Bill of Materials Backline 112/110 Preamp 206-0150-A

APPROVALS	DATE	TITLE
INT	10/10/01	BACKLINE 110/112 PRE-AMP
DESIGNED: R.A.G.	12/21/01	DRWING NO: 406-0150-A2
DRAWN: R.A.G.		PART NO: 206-0150-A2
ELEC:		COMPANY: GALLIEN-KRUEGER
MECH:		FILENAME: 6150A2 Backline 112 Preamp.sch
S/A:		
RELEASED:

L. CHANGE ALL POTS TO BRACKET STYLE.		APPROVALS		TITLE: BACKLINE 110/112 PRE-AMP	
INIT	DATE				
DESIGNED: R.A.G.	10/01/01			DRAWING NO: 406-0150-B2	REV. B2
DRAWN: R.A.G.	9/10/02			PART NO: 206-0150-B2	
ELEC:					
MECH:				COMPANY: GALLIEN-KRUEGER	
D/A:				FILENAME: 6150B2	
RELEASED:

1. CHANGE R5 TO 10.0K FROM 8.25K.		APPROVALS		TITLE: BACKLINE 110/112 PRE-AMP	
2. UPDATE ALL PAD AND HOLE SIZES.		INIT	DATE	DESIGNED: R.A.G.	10/01/01
3. CHANGE BOARD NO. TO 206-0191-A FROM 206-0150-B2.		DRAWN: R.A.G.	12/6/02	DRAWING NO: 406-0191-A	REV. A
		ELEC:		PART NO: 206-0191-A	
		MECH:		COMPANY: GALLIEN-KRUEGER	
		D/A:		FILENAME: 6191A	
		RELEASED:

Backline 112 Preamp 206-0191-A

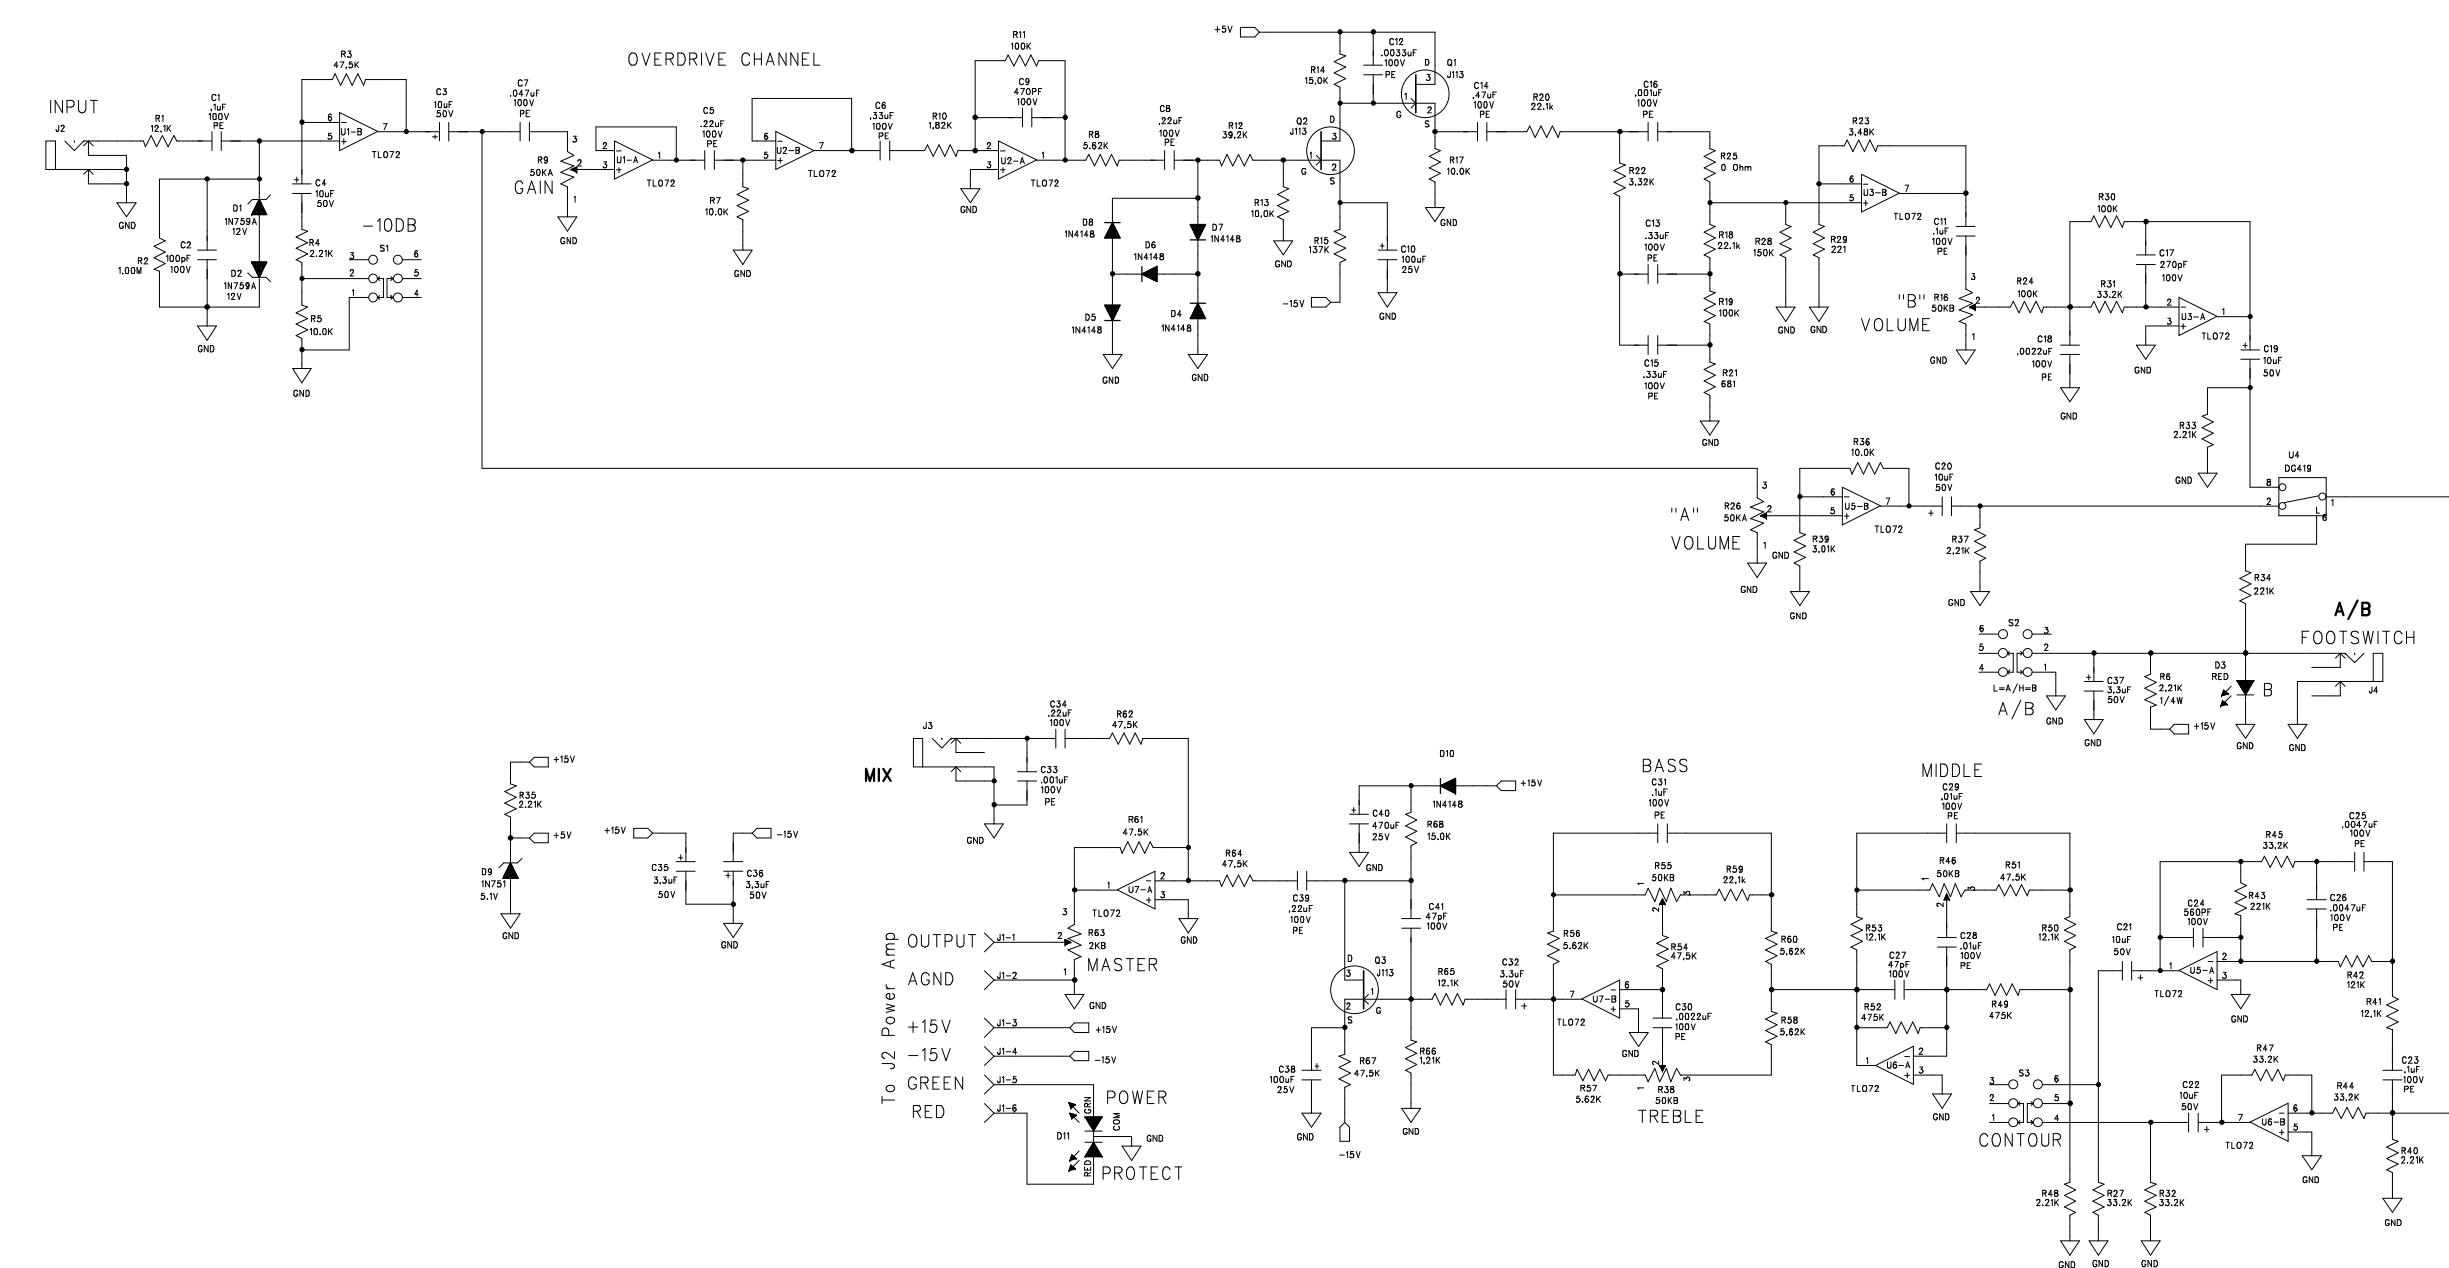
1. Change R5 from 8.25K to 10.0K.		<input type="checkbox"/>	Accounting		
2. Update all pad and hole sizes.		<input type="checkbox"/>	Assembly		
3. Change board number from 206-0150-B2 to 206-0191-A.		<input type="checkbox"/>	Customer		
		<input checked="" type="checkbox"/>	Engineering		
		<input type="checkbox"/>	Fabrication		
		<input checked="" type="checkbox"/>	Incoming Q.C.		
		<input type="checkbox"/>	Planning		
		<input checked="" type="checkbox"/>	Production Eng.		
		<input checked="" type="checkbox"/>	Purchasing		
		<input type="checkbox"/>	Q.A.		
		<input type="checkbox"/>	Receiving		
		<input type="checkbox"/>	Service		
		<input type="checkbox"/>	Vendor		
		<input checked="" type="checkbox"/>	Test		
		<input type="checkbox"/>			
<input type="checkbox"/> Continued on ECO Supplement Page		<input type="checkbox"/>	Drawing(s) attached		
Part Number	Description	Parts Added		Parts Deleted	
		Qty	Ref. Designator	Qty	Ref. Designator

APPROVALS	DATE	TITLE
DESIGNED: R.A.G.	10/03/01	BACKLINE 110/112 PRE-AMP
DRAWN: A.T.M.	04/07/04	DRAWING NO: 406-0191-A
ELEC:		PART NO: 206-0191-A
MECH:		COMPANY: GALLIEN-KRUEGER
S/A:		FILENAME: 6191A
RELEASED:

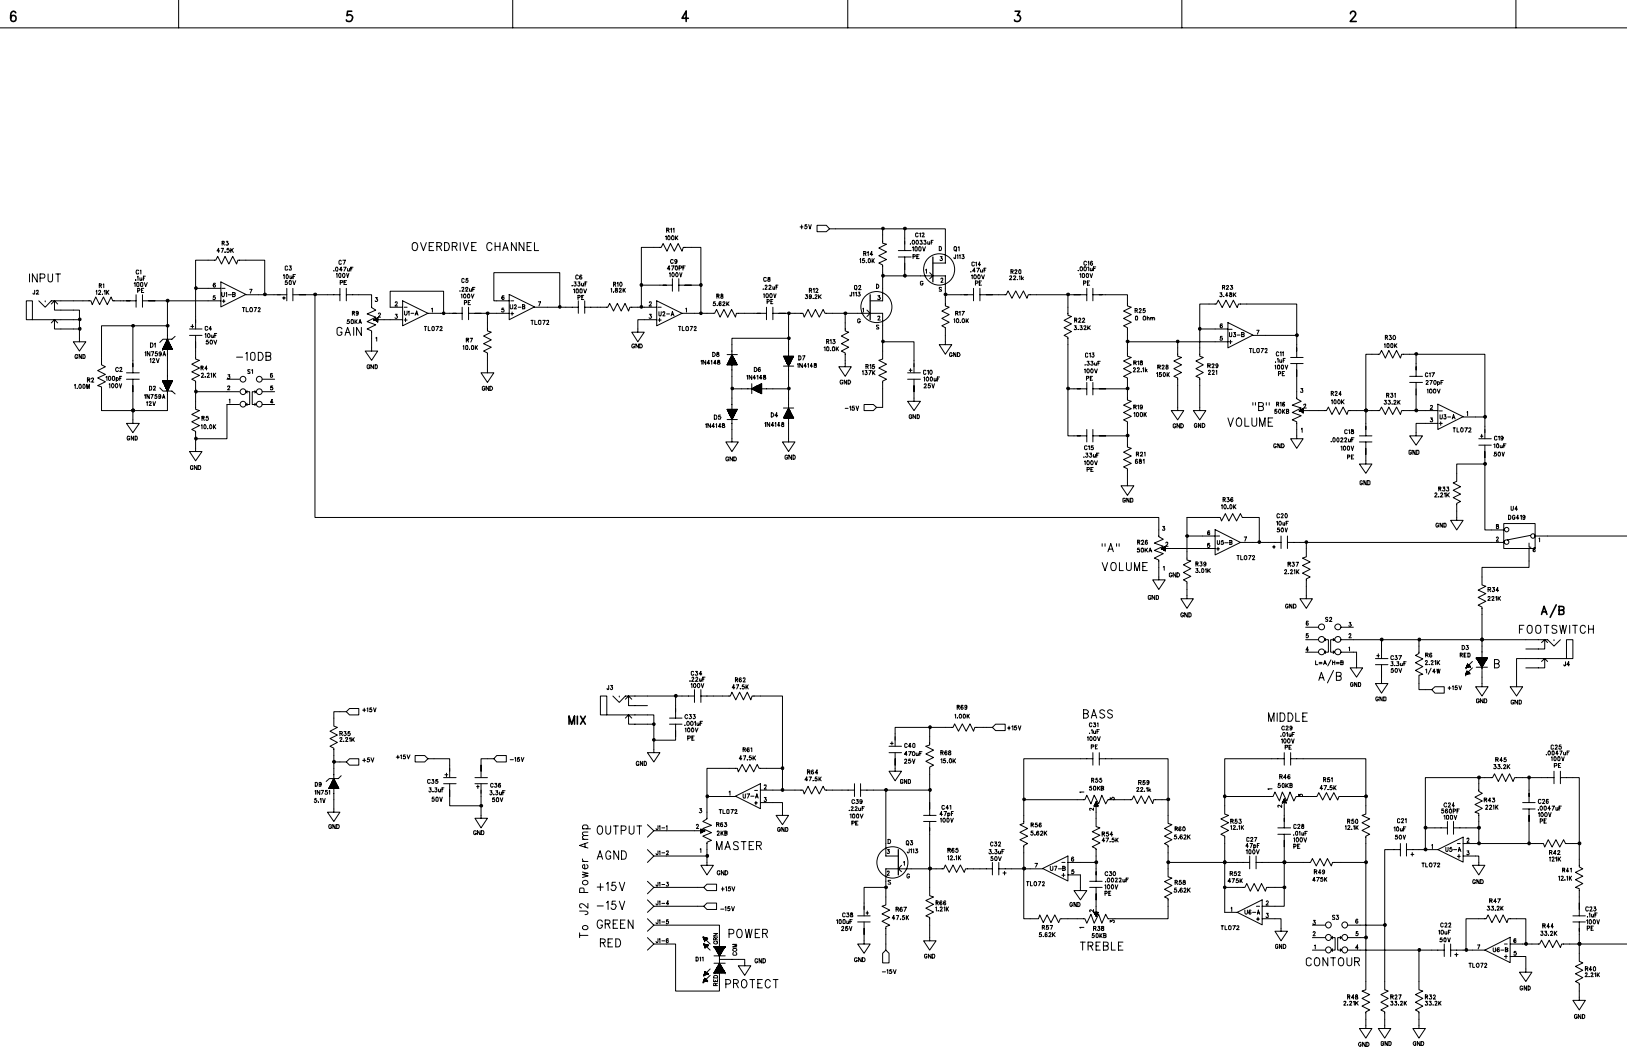
Description Of Change		Distribution		Date	Initials
Replace D10 with 1.0K resistor to bias the BOOST circuit properly.		<input type="checkbox"/>	Accounting		
		<input type="checkbox"/>	Assembly		
		<input type="checkbox"/>	Customer		
New reference designator is R69.		<input checked="" type="checkbox"/>	Engineering		
		<input type="checkbox"/>	Fabrication		
For current production, solder the 1.0K resistor in parallel with D10.		<input checked="" type="checkbox"/>	Incoming Q.C.		
		<input type="checkbox"/>	Planning		
		<input checked="" type="checkbox"/>	Production Eng.		
		<input checked="" type="checkbox"/>	Purchasing		
		<input type="checkbox"/>	Q.A.		
		<input type="checkbox"/>	Receiving		
		<input type="checkbox"/>	Service		
Update board # from 206-0191-A to 206-0191-A1		<input type="checkbox"/>	Vendor		
		<input checked="" type="checkbox"/>	Test		
		<input type="checkbox"/>			
<input type="checkbox"/> Continued on ECO Supplement Page		<input type="checkbox"/>	Drawing(s) attached

1. Replace D10 with R68, 1.0K resistor.
